Master Processor PROM in PT5210 Varitime [™] Digital Sync Generator

Supplement to: PT 5210 Reference: Manual no. 9499 491 02211

Picture 1: The positioning of the master processor PROM. The lower right corner on the PROM is indicated by a cut in the chip. (Note, that code number on actual PROM may differ from Photo)

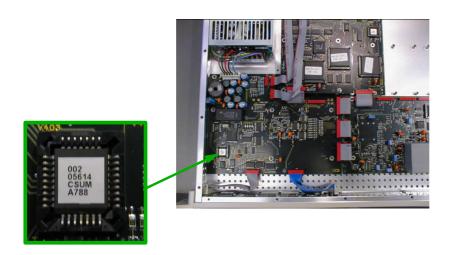
- 1. Open the PT 5210 by removing the top cover.
- Identify the master processor PROM on the processor module mounted flat behind the display module.See Picture 1
- 3. By use of suitable IC extractor remove the master processor PROM.
- 4. Insert the new processor PROM. Take care to orientate the PROM correctly.
- 5. Insert diode in fan circuit according to drawing.
- 6. Mount the top cover on the PT 5210.
- 7. Perform a factory reset: While pressing the two buttons ARROW RIGHT and ARROW LEFT simultaneously turn on the power.
- 8. Observe that the display reflects the changes included with the master processor change.

Present number is 4008 002 07221; checksum EE52
